ZONING AND PLATTING COMMISSION SITE PLAN REVIEW SHEET
ENVIRONMENTAL VARIANCE REQUEST ONLY
REVIEW SHEET

CASE: SP-2013-0110D

PROJECT NAME: 15101 Debba Drive

The site has already constructed fill over a portion of the tract with depths ranging from 0.5 feet to approximately 9.5 feet over the allowable 4 ft. The variance is to allow fill in excess of 4', but not to exceed 14' (LDC 25-8-342 (A)).

BACKGROUND

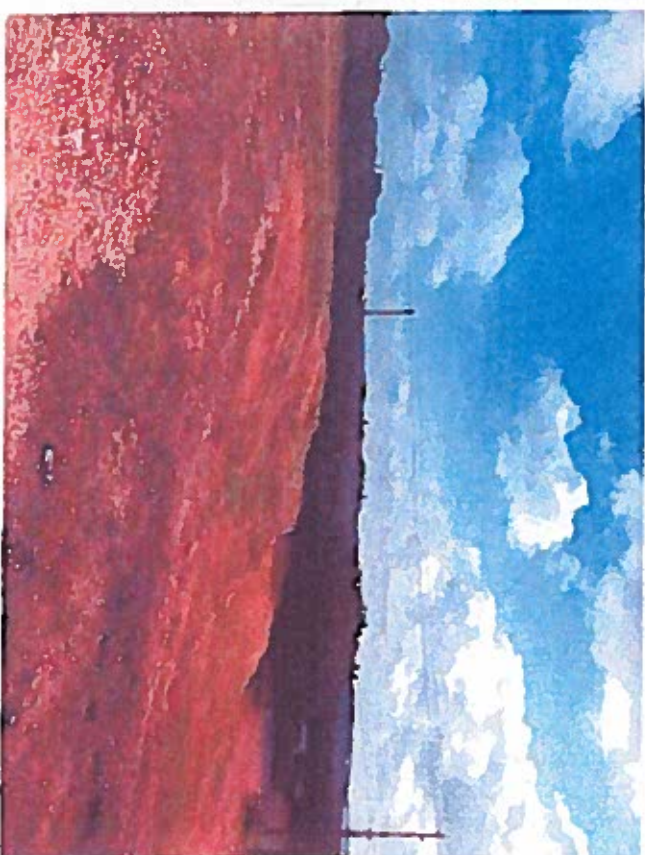
Site plan proposed to restore & revegetate site due to Stop Work Order issued August 2009.

Original development was single family use, now commercial use.

Applicant says he obtained basic development permit from Travis County and did not know about CoA regulations.

Fill exceeds 13' in height and is partially located in the required 40% buffer area.

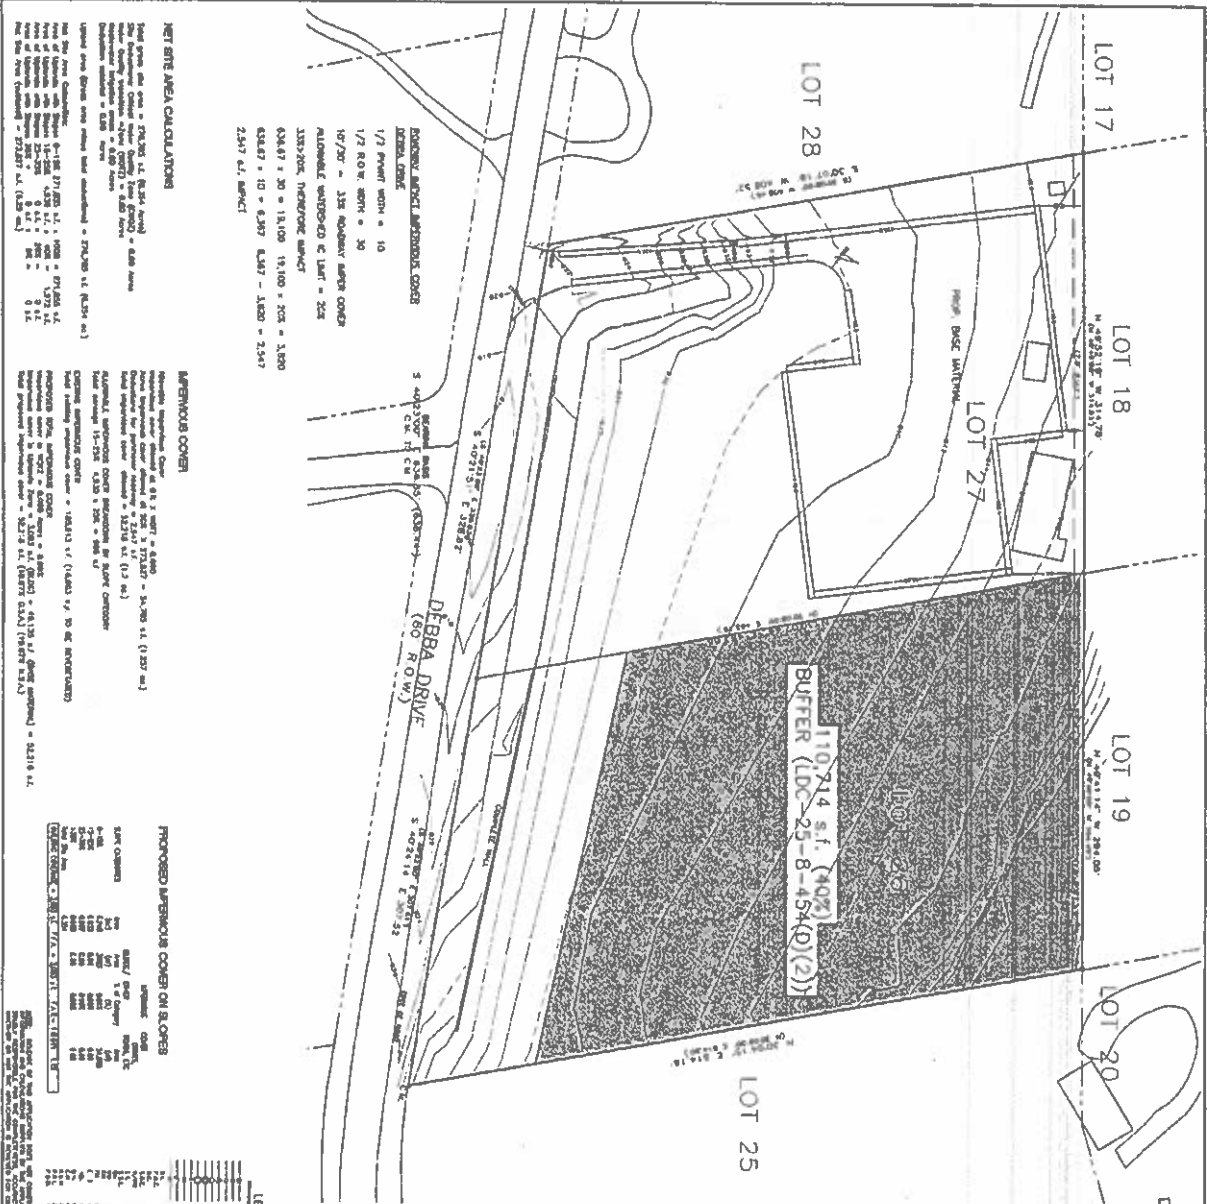
Comments: I own the lot directly next to this property. The lot in question has been raised so high with fill that the drainage onto my property has been significantly changed in a negative way. At some points the lot in question is now 5-6 ft. higher than my property and they were previously the same elevation.
